August 8, 2017

Alan Day, General Manager
Brazos Valley Groundwater Conservation District
112 West Third Street
Hearne, TX 77859

**Reference: Public comments regarding BVGCD Proposed Rule
Amendments dated August 10, 2017**

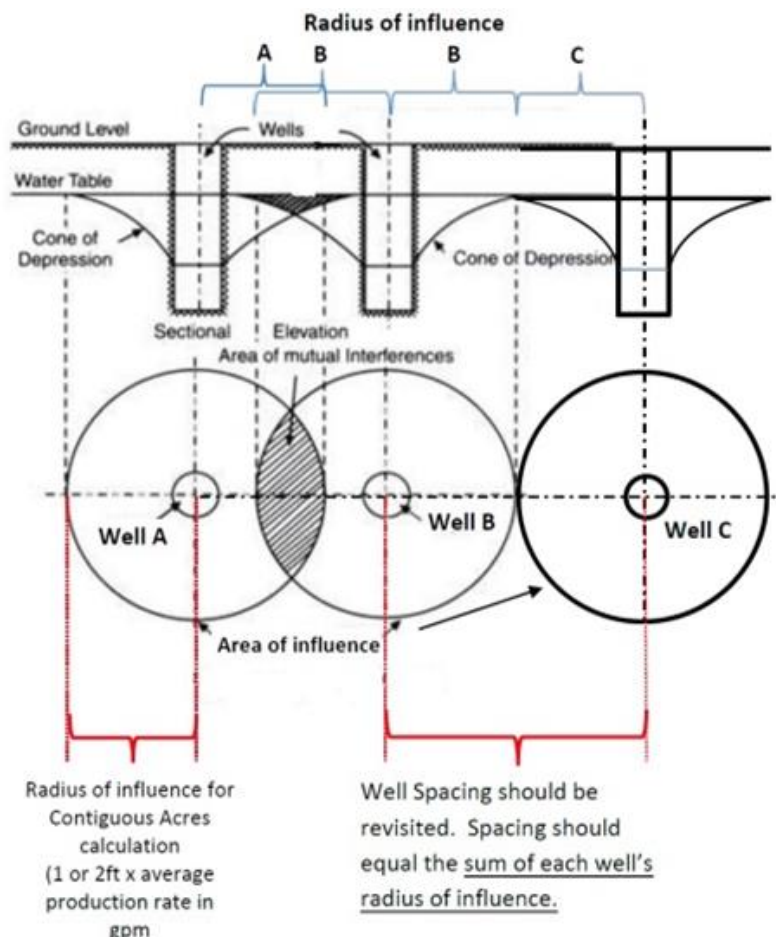
Example 2. 3000 acft/yr permit is proposed as an average production rate of 1860 gpm to yield 3000 acft/year and therefore requires a distance of 1860 feet between well heads and legal control of approximately 250 acres.

I am assuming the Board’s hydrologist has sanctioned the second version as probably closer to calculating the surface *area of influence* created by a pumping well’s *cone of depression*. However, this wellhead to wellhead distance only extends to the perimeter of the new well’s *area of influence*. This well spacing distance may interfere with **existing wells** and negatively impact production of both.

If the Board's current formula for assigned acreage is representative of a well's impact, then the well-spacing calculation should be revisited. My suggestion is to either create a table for reasonable well-spacing or amend the rule to sum the value of each well's *radius of influence* to determine an appropriate distance between wellheads. Otherwise, just using the new well's radius would favor the new intruder rather than protecting the existing well's permit.

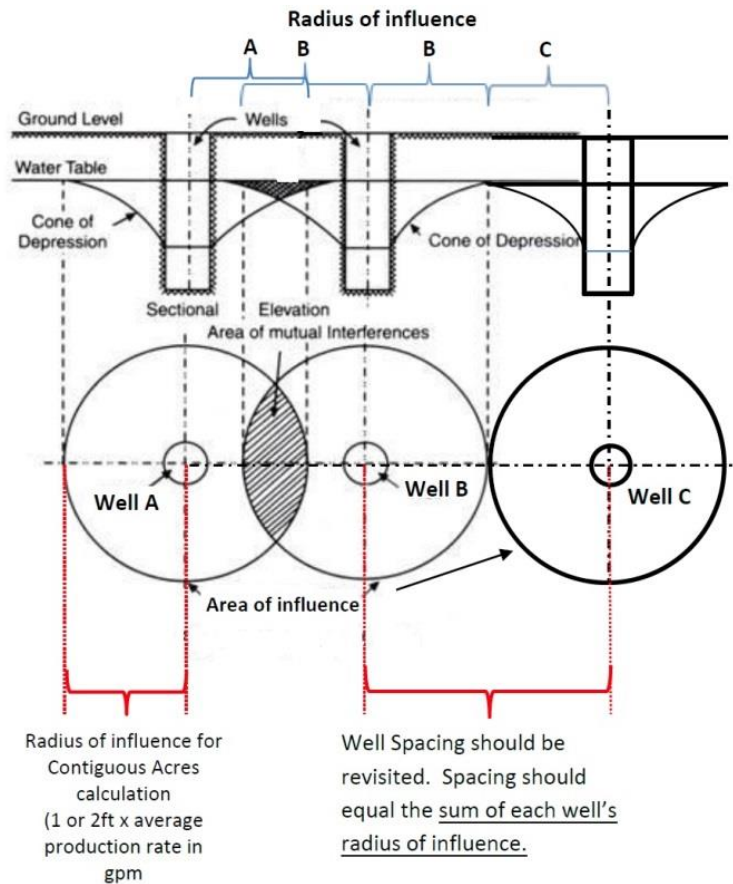
It is my opinion that Rules 6.1.b(1,2 & 3) should be revisited. Currently, the BVGCD well spacing Rules 6.1.b(2 & 3) of 1ft/GPM and 2ft/GPM represent the *lateral radius of influence* of only the new well and NOT the well spacing expected to avoid interference of an adjacent permitted or registered well. A new well should not be operated in such a manner to significantly reduce the production from previously existing wells. It is assumed the 1ft/gpm is a reasonable guide (multiplier) based on the BVGCD's hydrologist's best estimate for the Simsboro aquifer to determine the *radius of influence* in our geographic locale.

[The essential question is which is correct. Is 1ft times well rate in gpm the appropriate distance between wells? Or, is 1ft times well rate in gpm the *radius of influence*? I have trouble accepting this same function as representing these two different distances.]

Well spacing should not be the outer boundary (circumference) of the *area of influence*. The existing permitted or registered well may have a significant cone of depression that should be considered.

Equivalent radius formula for determining ideal distance (d) between congruent wells is $d = \sqrt{\pi r^2}$ where r is the *lateral radius of influence*. Otherwise, the wells of varying size and capacity would be properly space at a distance (d_2) equal to the sum of their radii, $d_2 = r_{\text{well B}} + r_{\text{well C}}$

Two wells of any area should be spaced in such a way that the cones of depression or areas of influence do not cross each other. Mutual interference reduces the dependable groundwater storage of each well and, in turn, reduces the discharge of both wells. Also, consideration should be given to the inevitable dynamics of time's relationship with the *area of influence* which will increase.
